**GENOA CHARTER TOWNSHIP BOARD**

**April 4, 2016  
Regular Meeting  
6:30 p.m.**

**RE:** **GILDEN WOODS CHILD CARE - LIVINGSTON COMMONS PHASE 2**  
Environmental Impact Assessment and Final PUD Site Plan

<b>Attention:</b>	Kelly Van Marter, AICP Planning Director and Assistant Township Manager
<b>Subject:</b>	Gilden Woods Day Care – Site Plan Review #2
<b>Location:</b>	Grand Oaks Drive – vacant parcel on northwest side of Grand Oaks, west of Latson Road
<b>Zoning:</b>	NR-PUD Non-Residential Planned Unit Development District

1 DUMSTER ENCLOSURE PLAN  
A-22 SCALE: 1/4" = 1'-0"

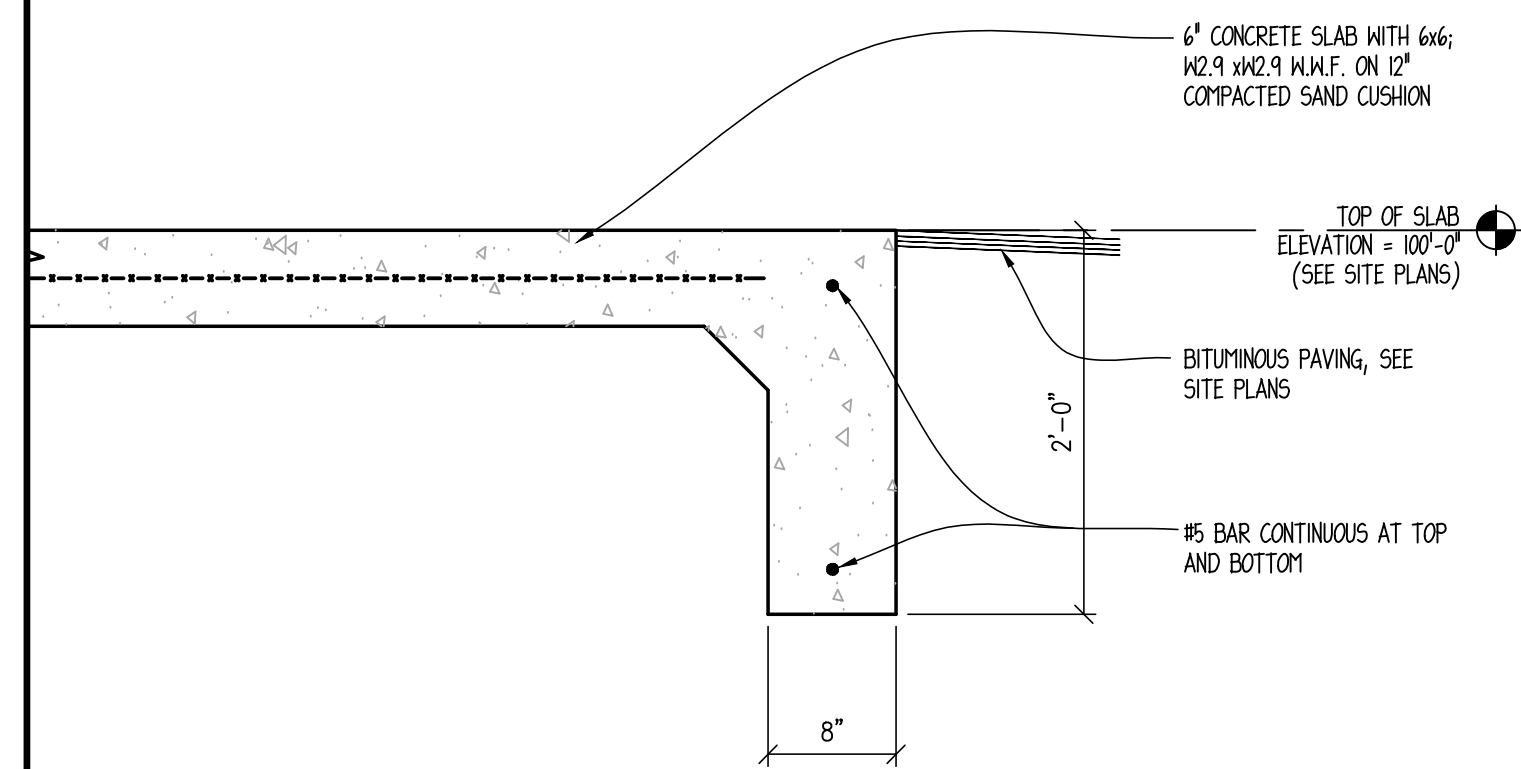
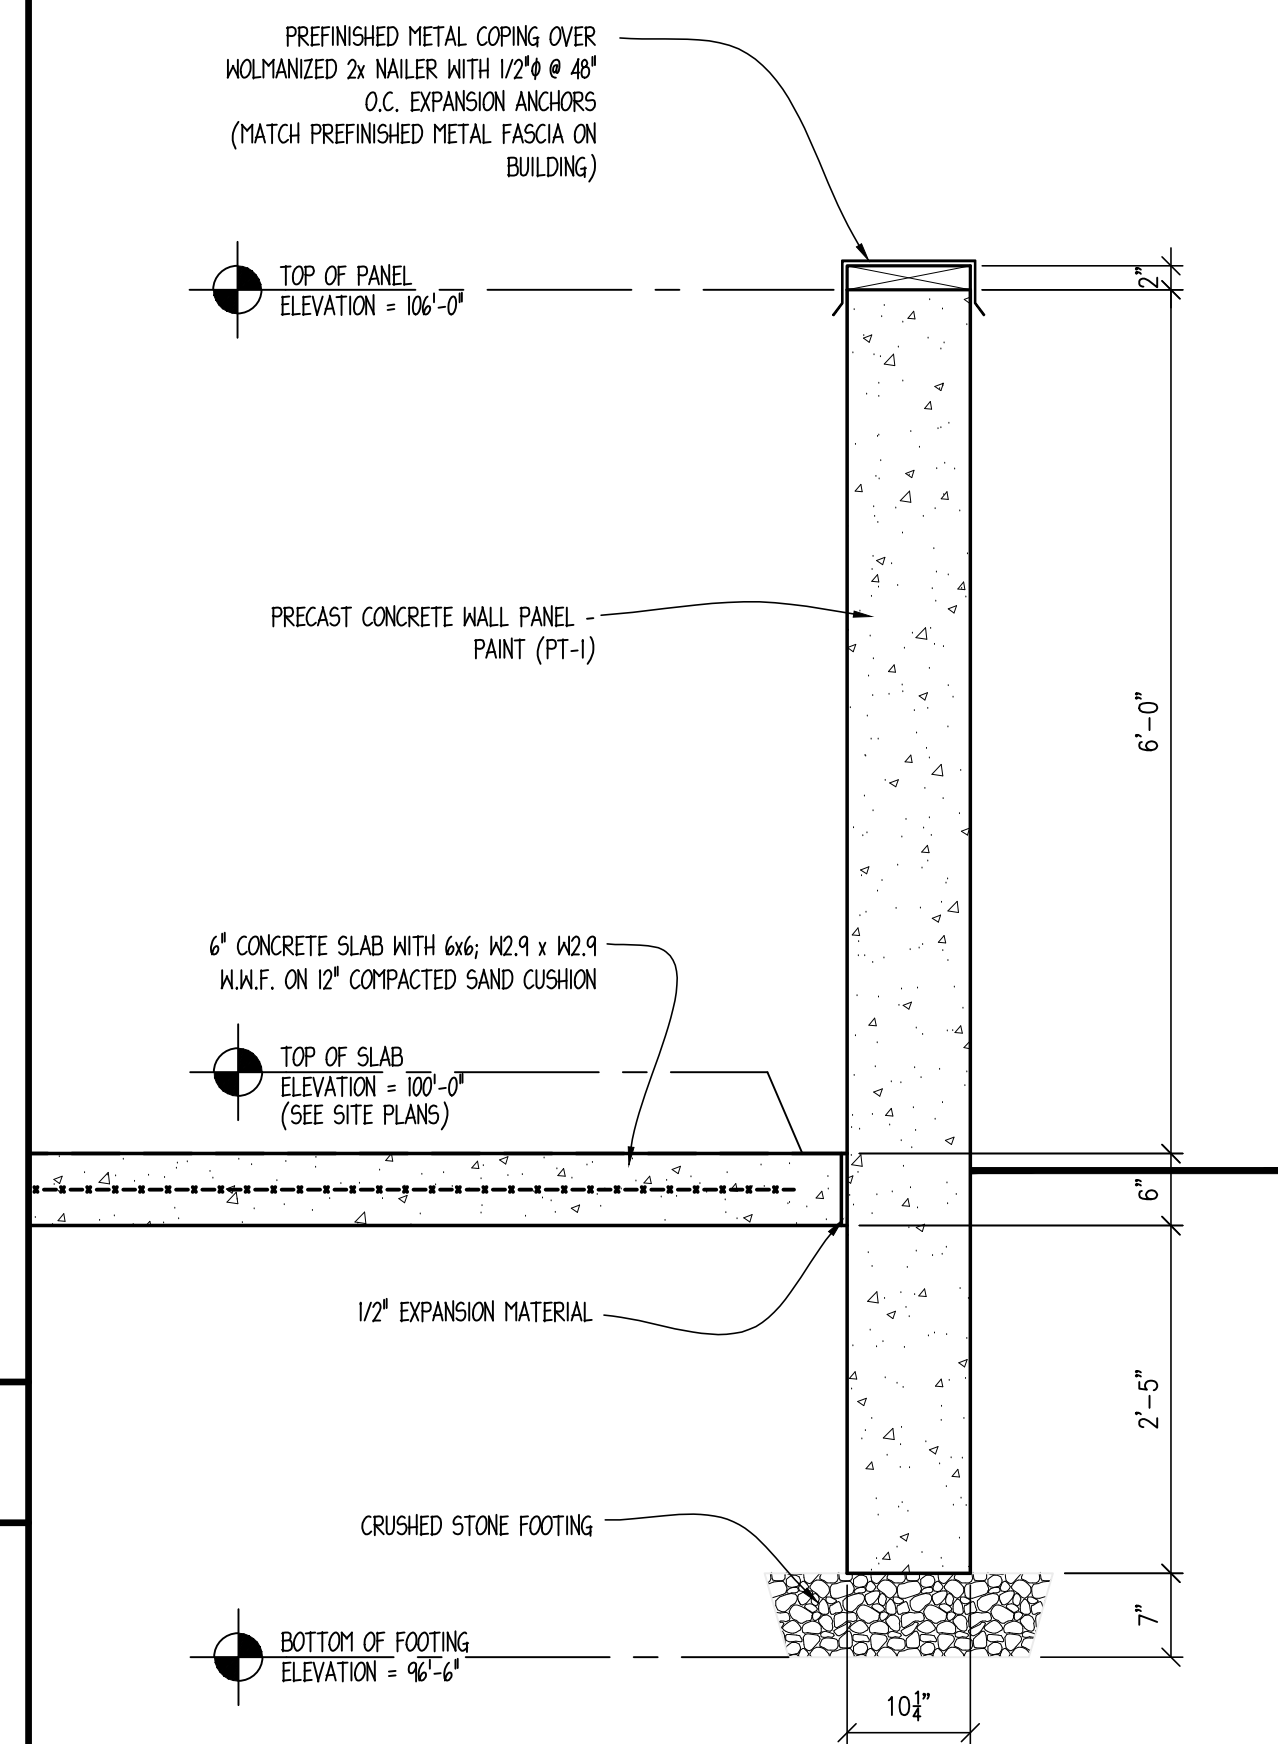
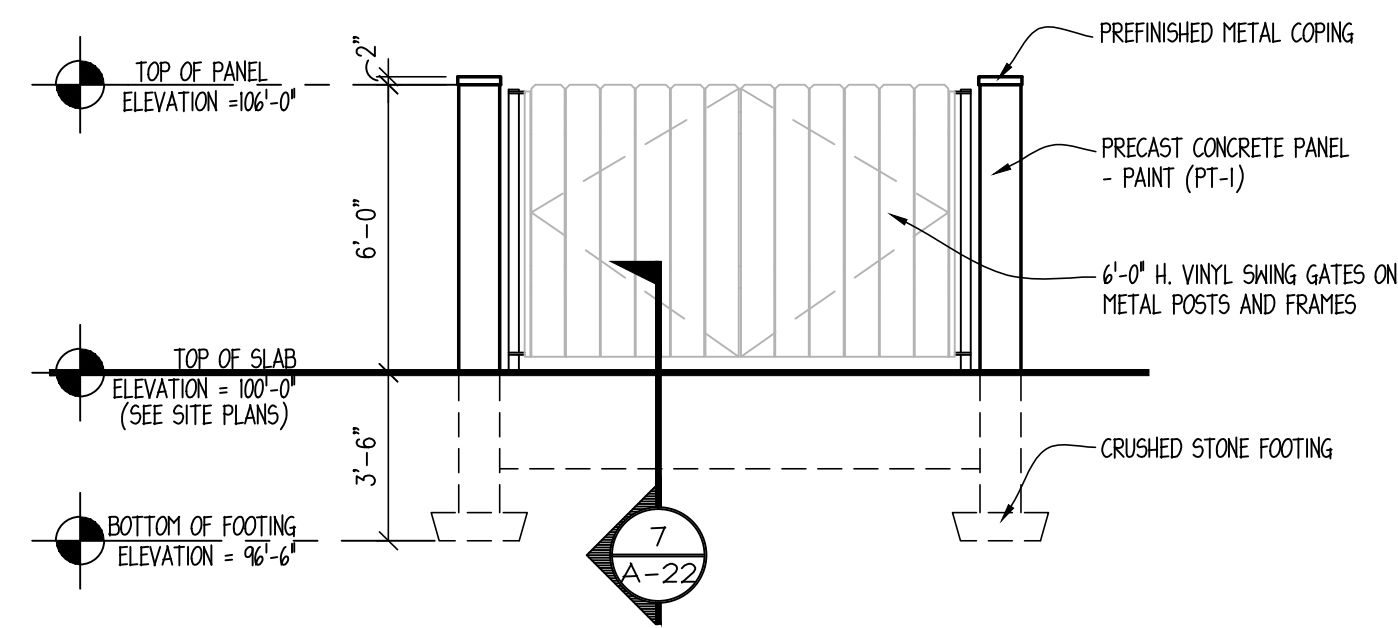
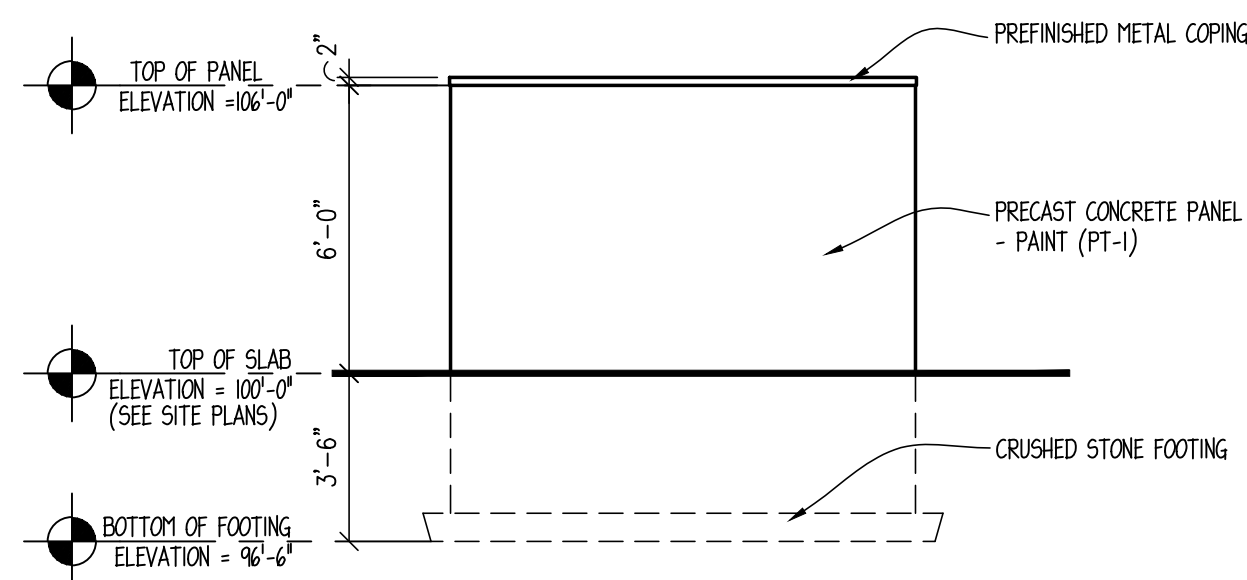
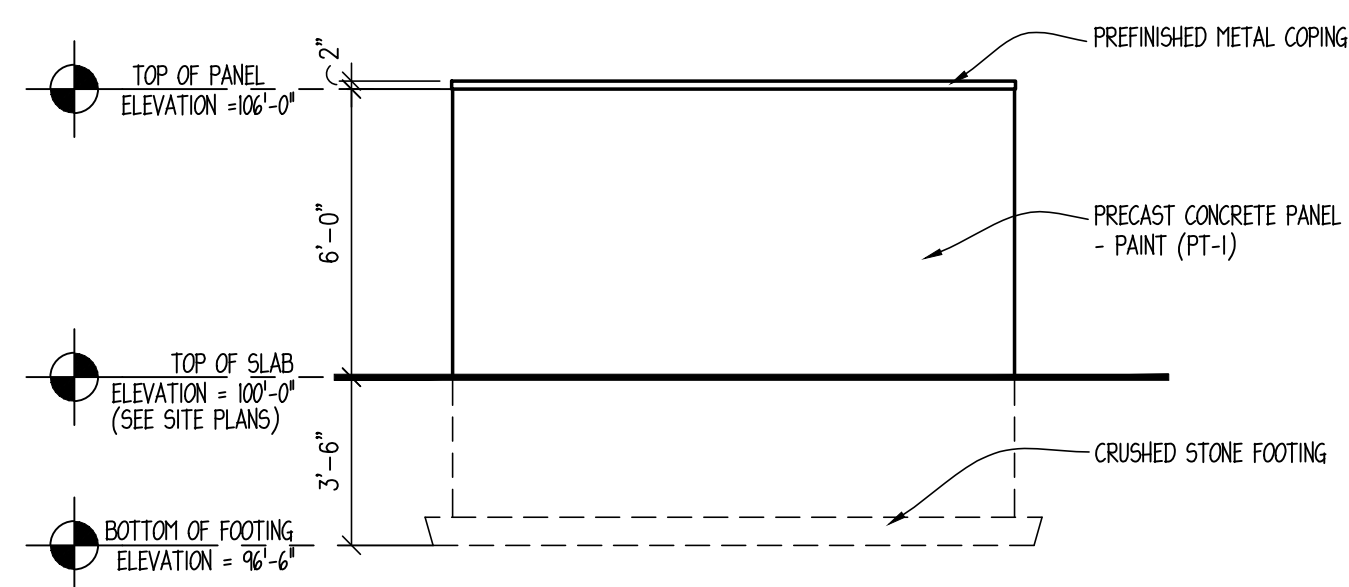
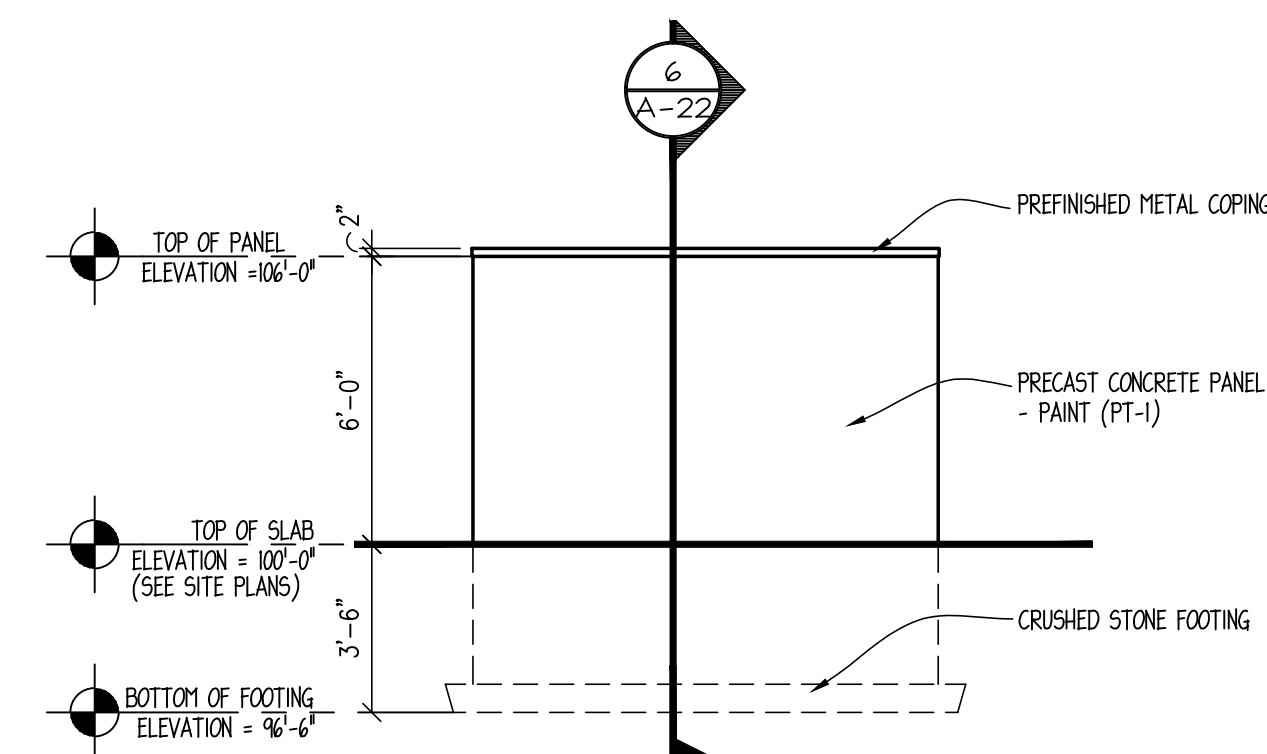
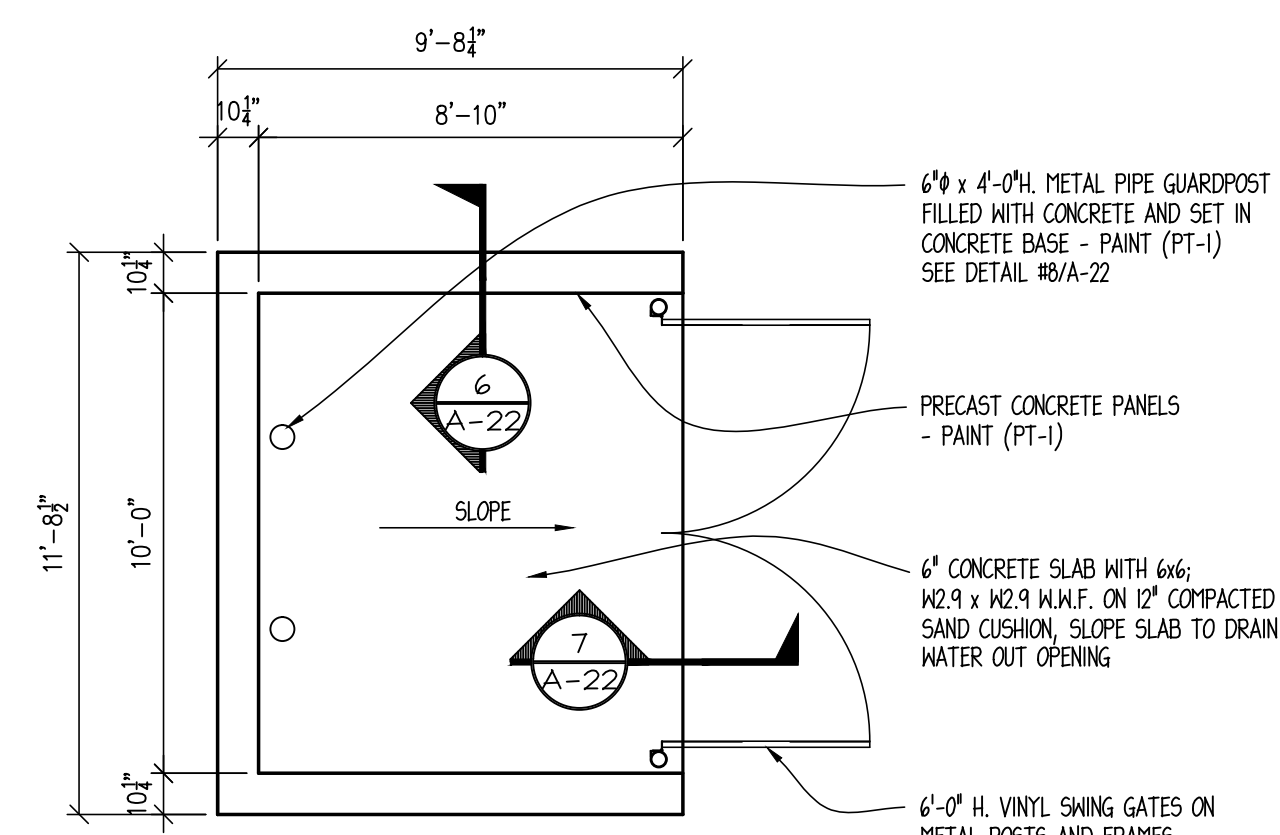
Details on Sheet A-22 identify a concrete base pad and a painted concrete enclosure, which is to match materials used on the building. Our only comment is that the depth of the concrete base pad must be extended to support the weight of refuse removal vehicles.
